Re: Approval of Change Order #14 with Pence/Kelly Contractor

CHANGE ORDER

PROJECT: Courthouse Square
(name, address) 555 Court Street NE
Salem, Oregon 97301

CHANGE ORDER NUMBER: 14

PROJECT NAME COURTHOUSE CALCULATED BY T3 DATE 7/30/99
PROJECT NO. _____ CHECKED BY _____ DATE _____
SUBJECT COLUMN C 10B + M SHEET NO. _____ OF _____

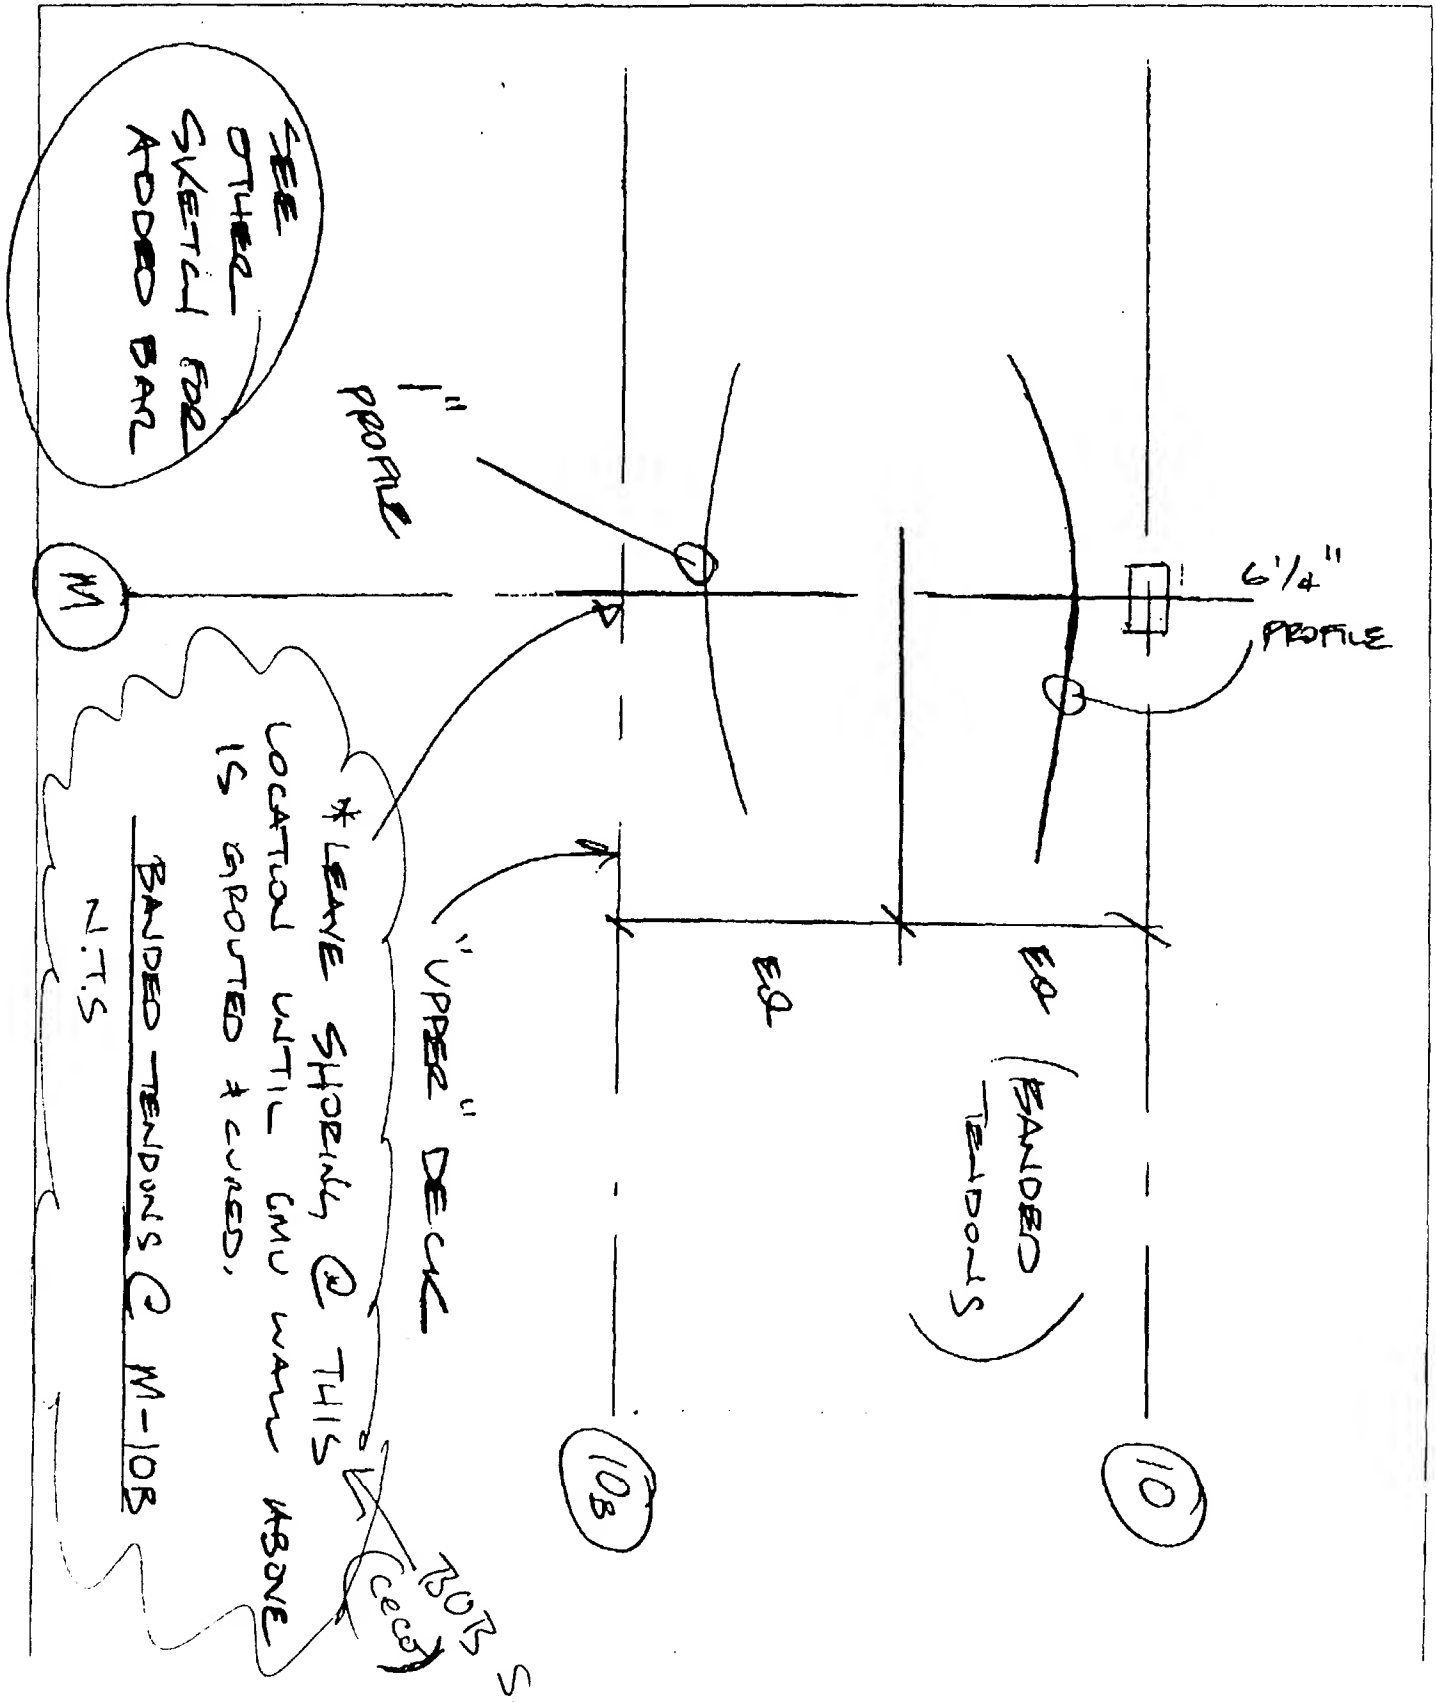
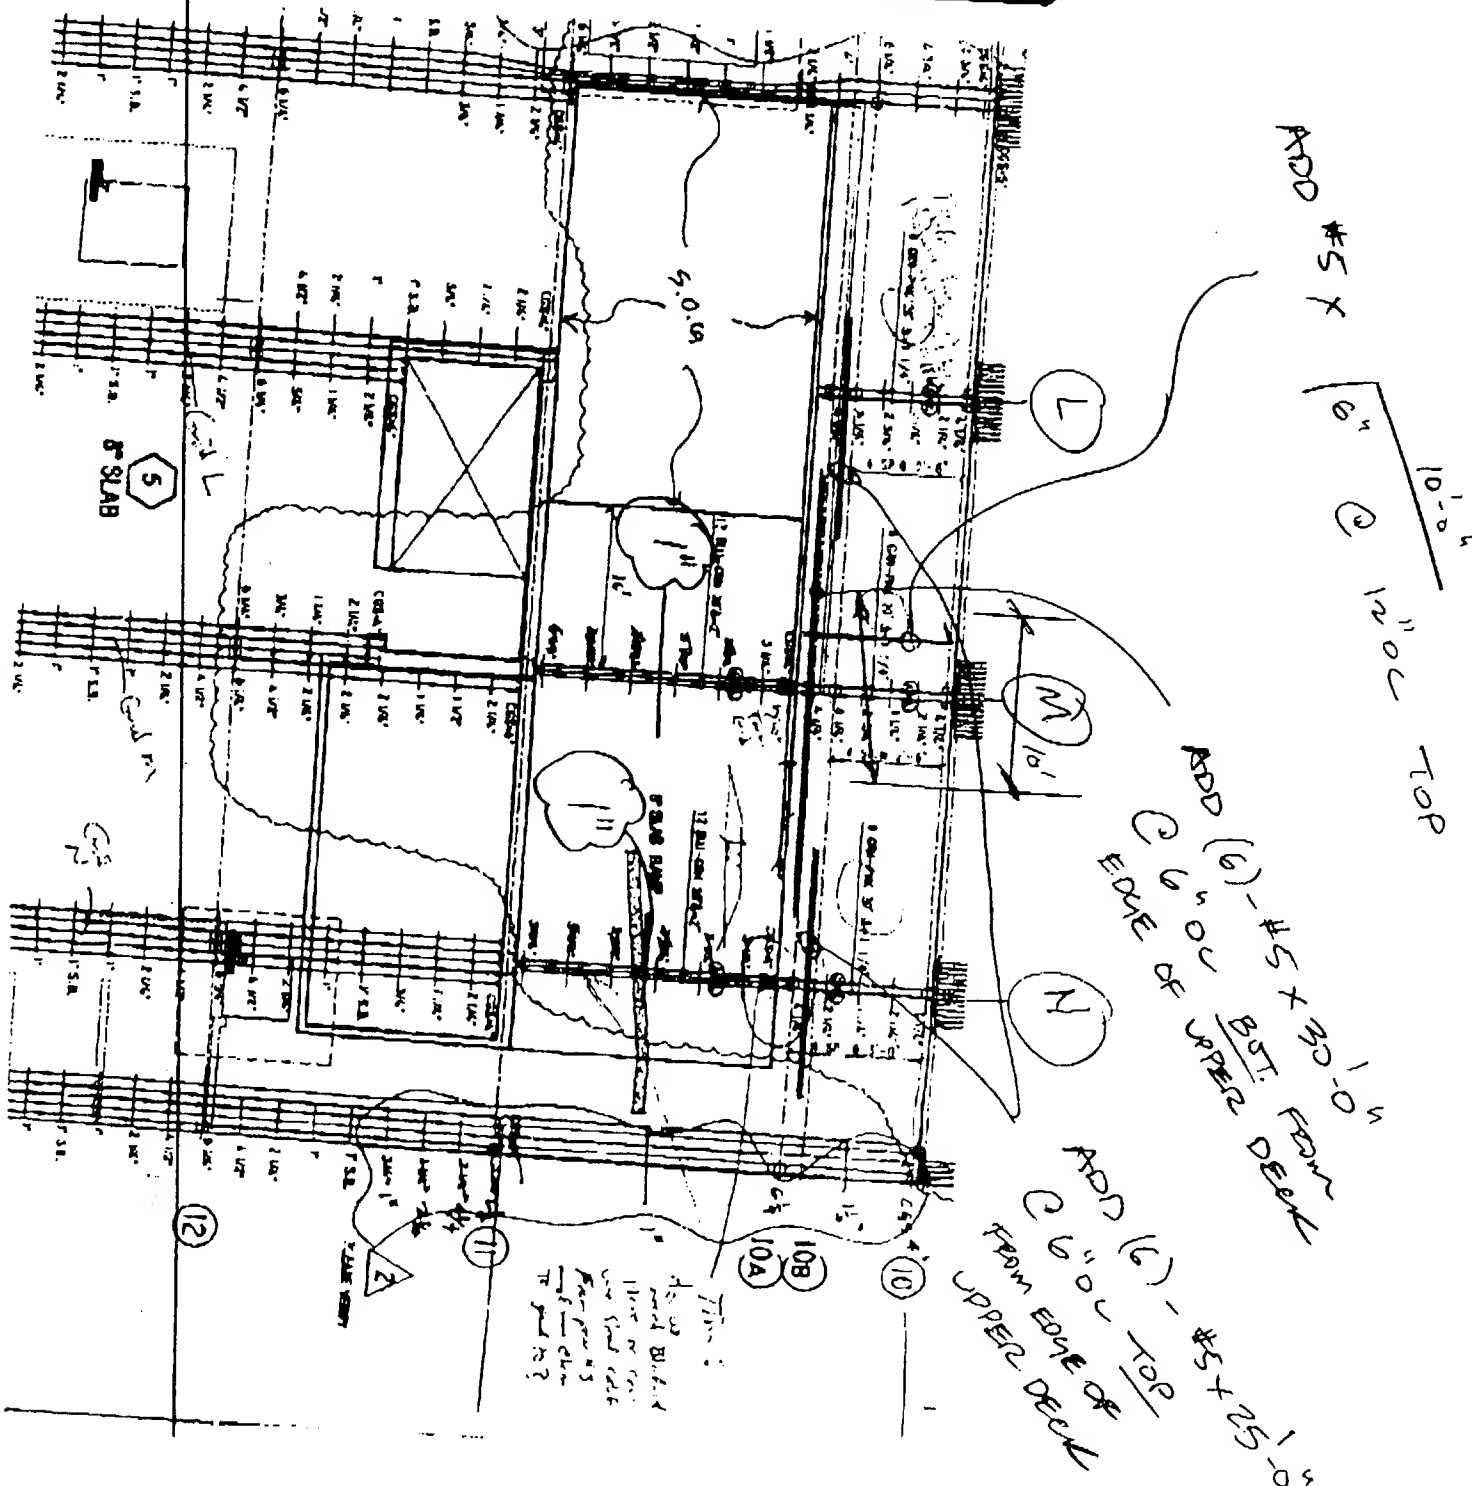
ATTACHED ARE REINFORCING & PT
ADJUSTMENTS FOR THE "UNSUPPORTED"
AREA @ GRID INTERSECTION M & 10B.
AND MODIFIED PROFILE OF BANDED
PT @ RAMP

Provide additional PT cables and reinforcing adjustments for the "unsupported" area @ grid M/10b, also modify profile of banded PT at ramp per Tim Terich fax dated 7/30/99.
